No: 25-024

DAUPHIN COUNTY SUBDIVISION/LAND DEVELOPMENT REVIEW REPORT

Plat Title: Eugene R. & Janice E. Sweigard

Project Description: Proposed Two Lot Subdivision

Drawing No: HT-395

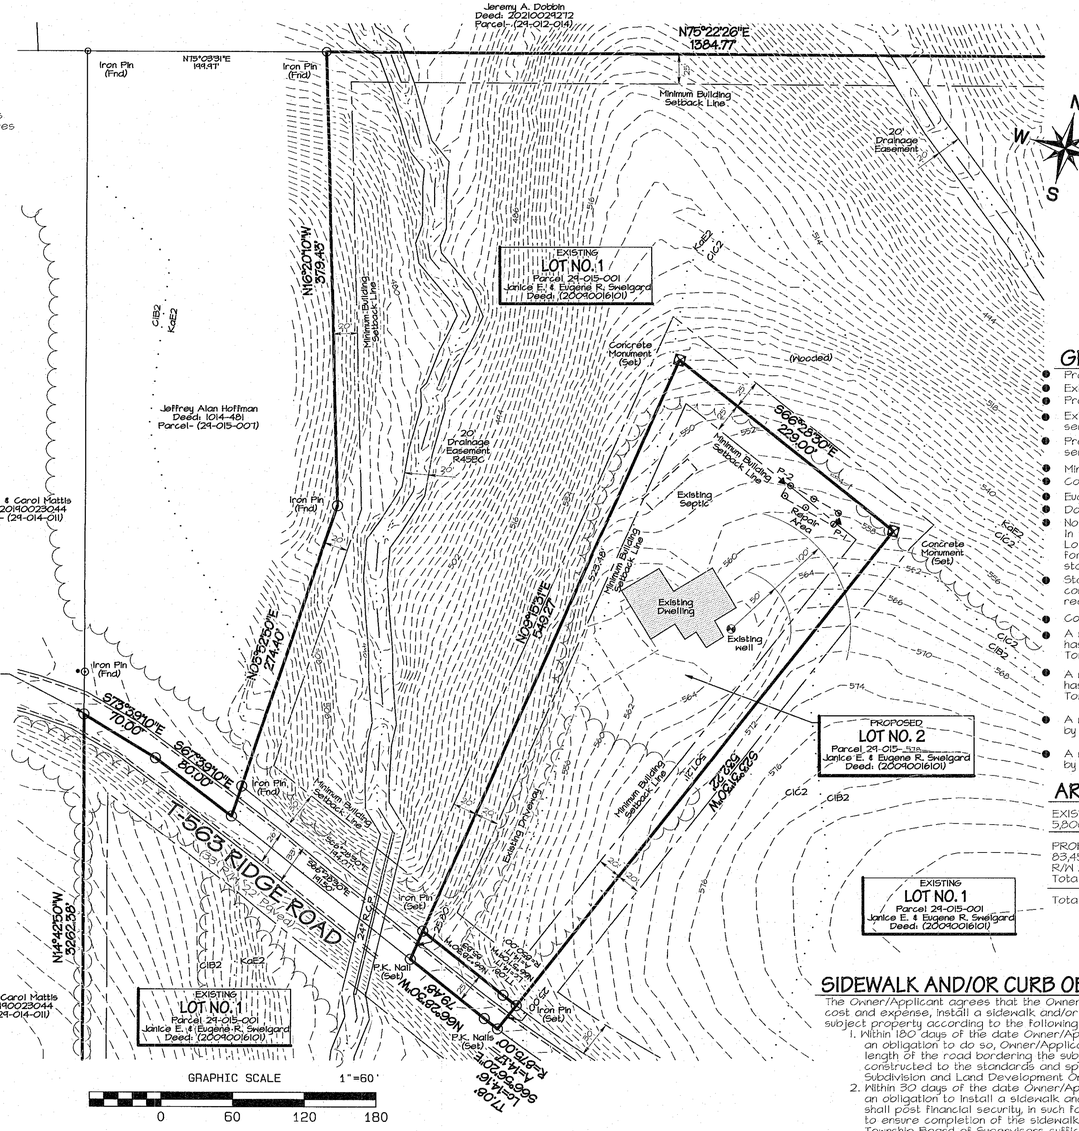
1. The plan shall be drawn at a scale not less that 1"=50'. (S-LD § 405.1.a per 407.1.a) The plan displays the applicants intent to request a modification of this requirement.

2. The location map is required to be drawn at a scale not less than 1"=1,000' (S-LD § 405.1.a.iv per 407.1.a)
3. All signatures, seals, and notarizations must be acquired upon final plan approval. (S-LD § 407.1.a.xi)

4. Any existing and proposed easements are required to be displayed on the plan for reference (S-LD § 405.1.a.ix per 407.1.a) – This includes any existing utilities (underground or overhead).

5. Drainage easements shall be at least 30' in width. (S-LD § 503.3) Drainage easements in the plan are only 20' in width.
6. The minimum lot width is 150'. (S-LD § 505.3.A) The plan displays the applicants intent to request a modification of this requirement.

7. Curbs on the site may be required in accordance with Section 606 of the Halifax Township SALDO. The plan displays the applicants intent to request a modification of this requirement.

8. Sidewalks on the site may be required in accordance with Section 607 of the Halifax Township SALDO. The plan displays the applicants intent to request a modification of this requirement.

9. The final Erosion and Sedimentation Control Plan is required to be in accordance with *Section 507* of the Halifax Township Subdivision Ordinance. The reviewer note the no earth disturbance is proposed with this plan.

10. The final Stormwater Management Plan is required to be in accordance with *Section 508* of the Halifax Township Subdivision Ordinance. The reviewer note the no earth disturbance is proposed with this plan.
11. Monuments and markers shall be set in accordance with S-LD § 602.
